CITY OF ALBUQUERQUE

Re: Princeton Cultivation 3701 Princeton NE Traffic Circulation Layout Engineer's/Architect's Stamp 2/10/2024 (G16D159)

TRAFFIC CIRCULATION LAYOUT APPROVED			
Sertil A. Kanbar	6/10/2024		
Signed	Date

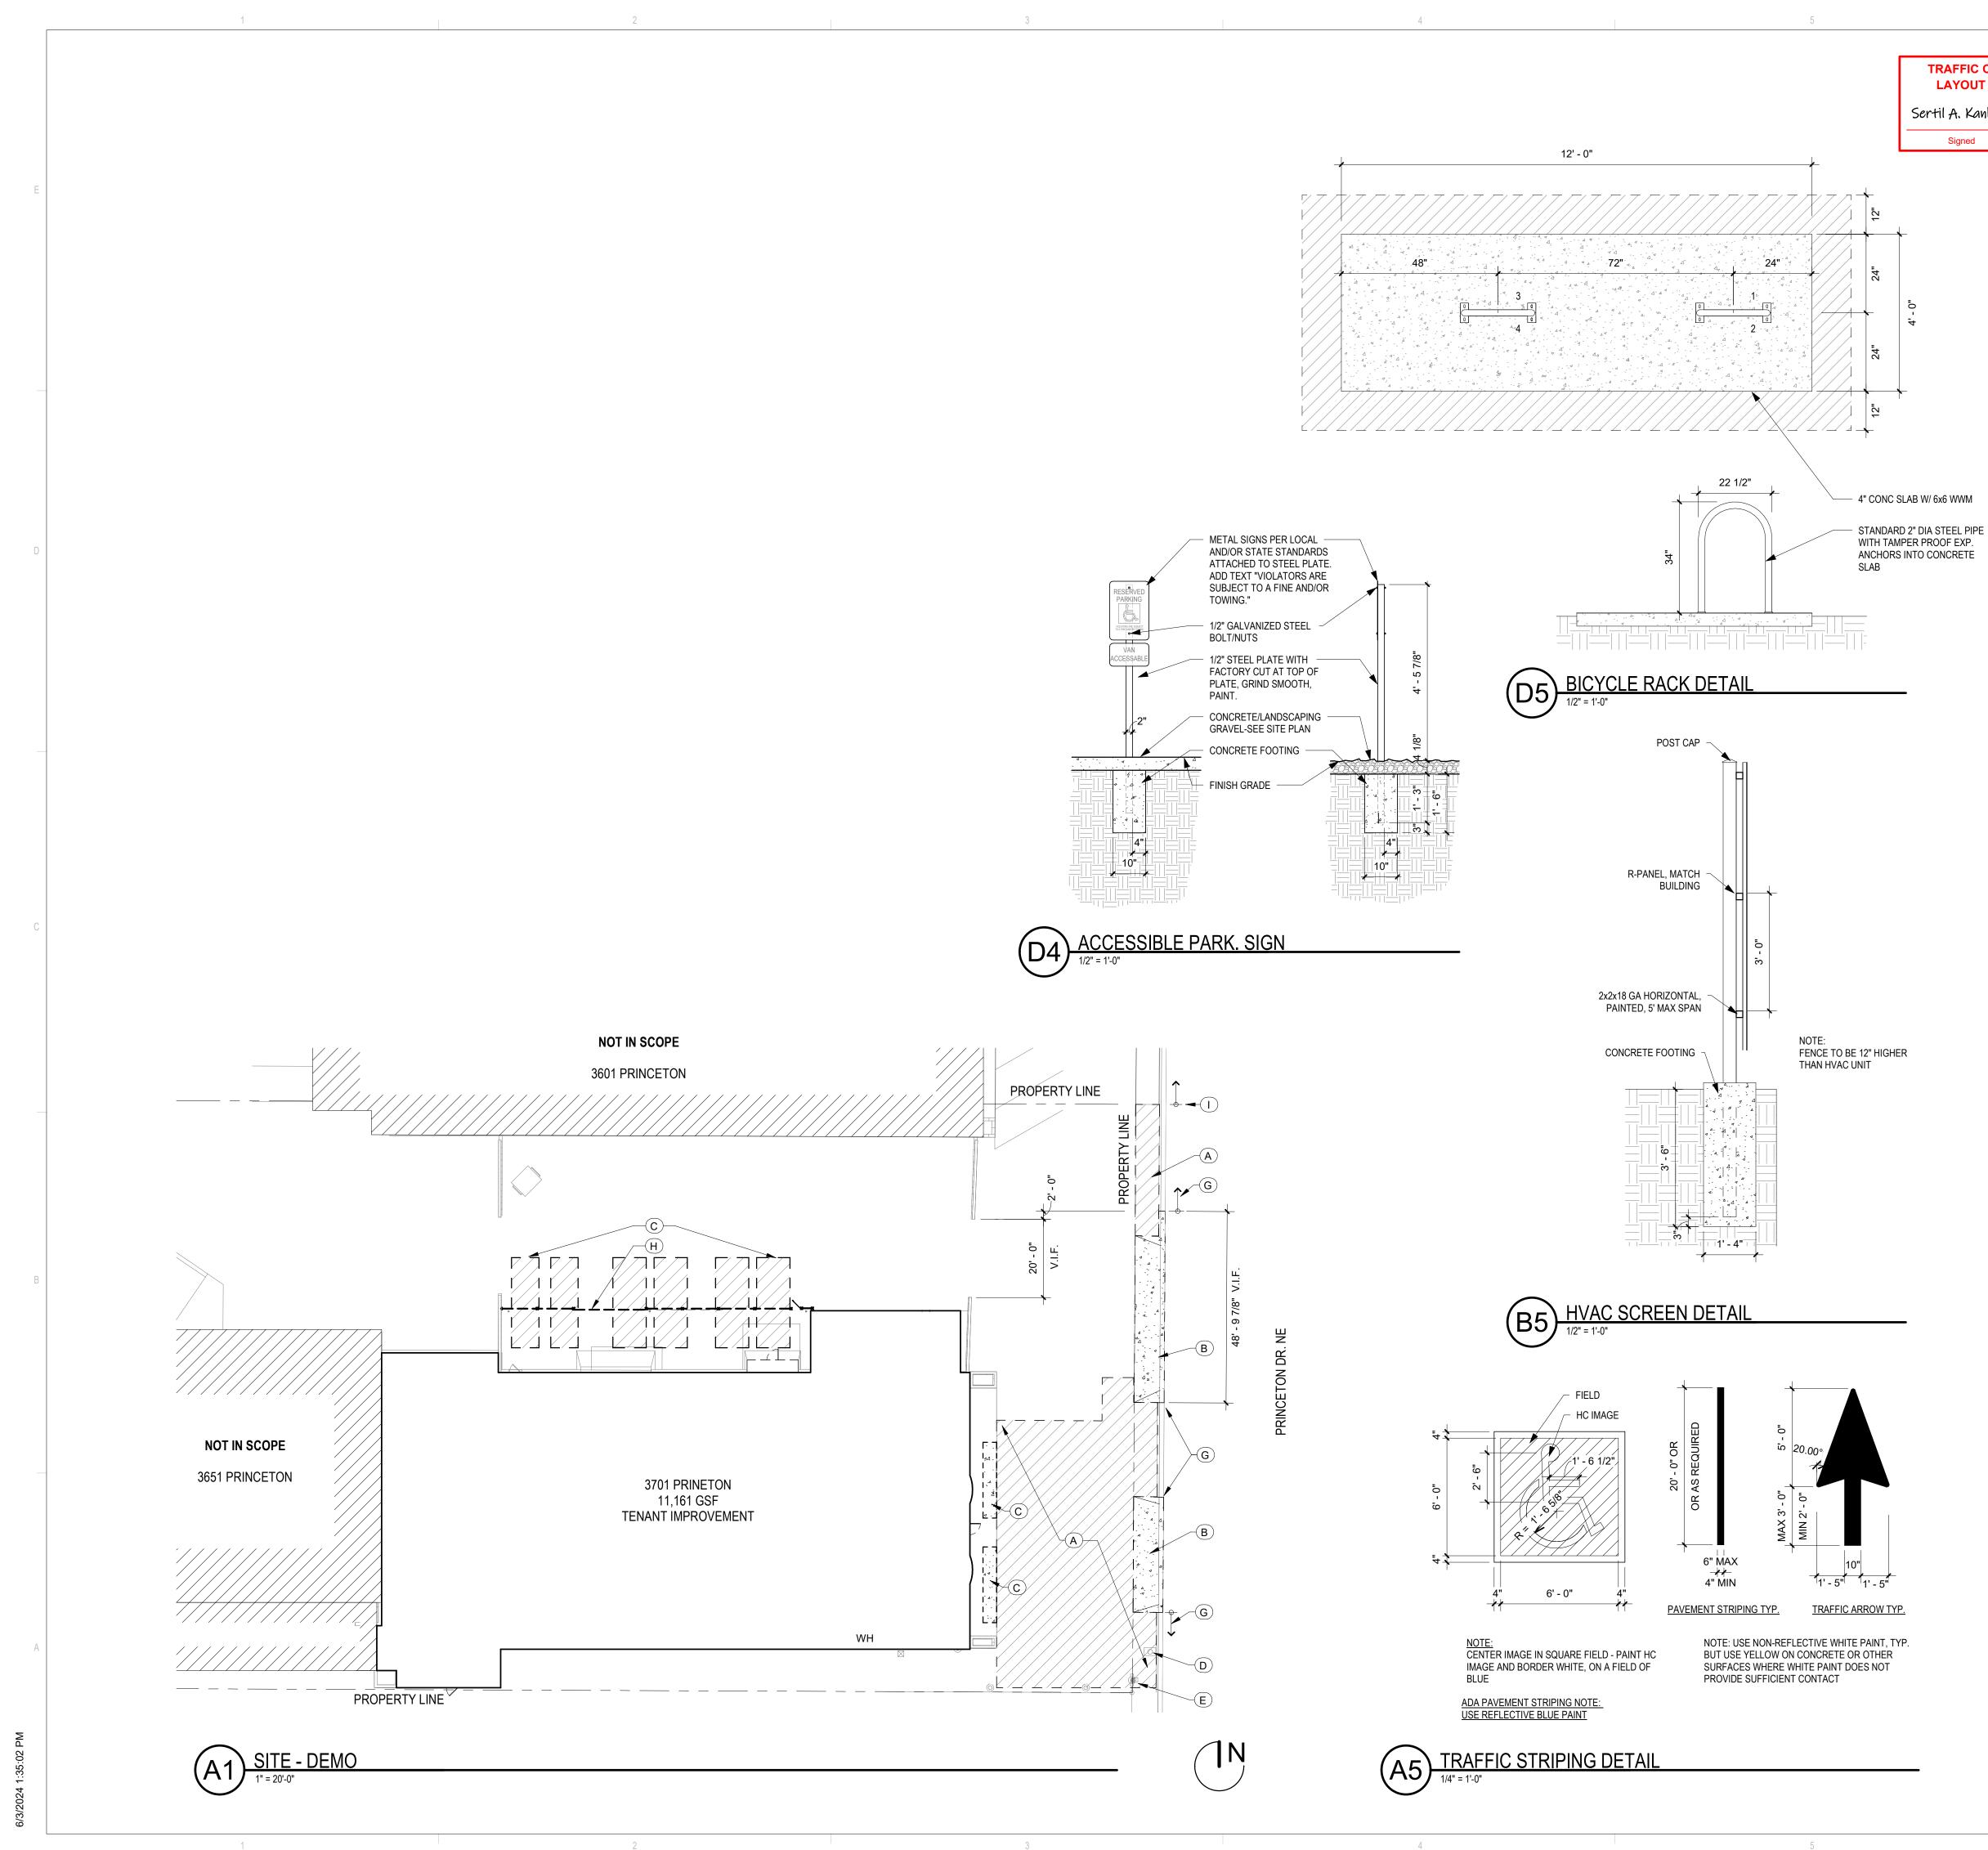
The TCL submittal received 5-6-2024 is approved for Building Permit by Transportation. A copy of the stamped and signed plan will be needed for each of the building permit plans. Please keep the original to be used for certification of the site for final C.O. for Transportation.
